**Royal Southern Yacht Club:  
Response to Lymington Technical Services Ltd Comments – Document  
10264v1**

Date: February 2013

Project Ref: R/4108/1

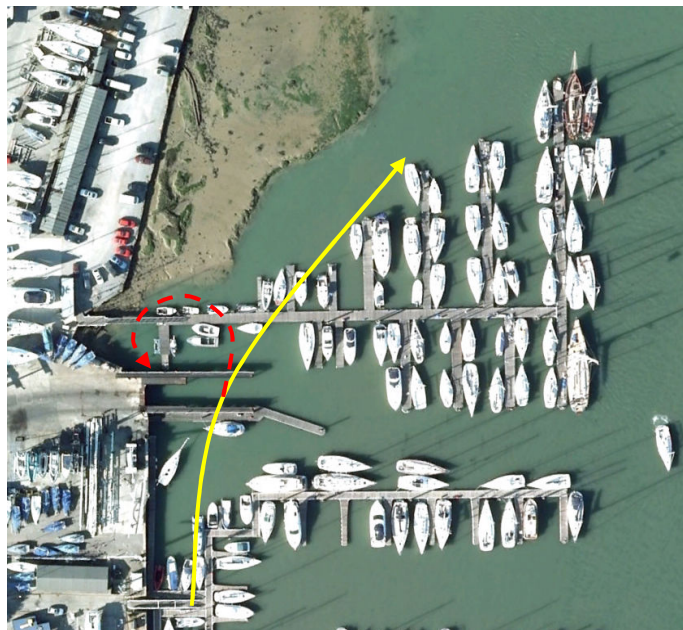
- **Page 8:** It is also true that the flood tide passes through Port Hamble and exits to the NE towards the main channel. Because of the shape of the dredging at the upstream end of Port Hamble the formation of an eddy at the upstream location is unlikely.

Based upon the shape of the dredge pocket, the presence of the vessels and the general realignment of tidal flows towards the northern end of Port Hamble Marina, it is expected that a small eddy will be created in the north-west corner (shown on image), particularly on the rising tide before the upstream intertidal becomes submerged. This being said, the presence of an eddy (or not if the case may be) will not be affected by the proposed works.
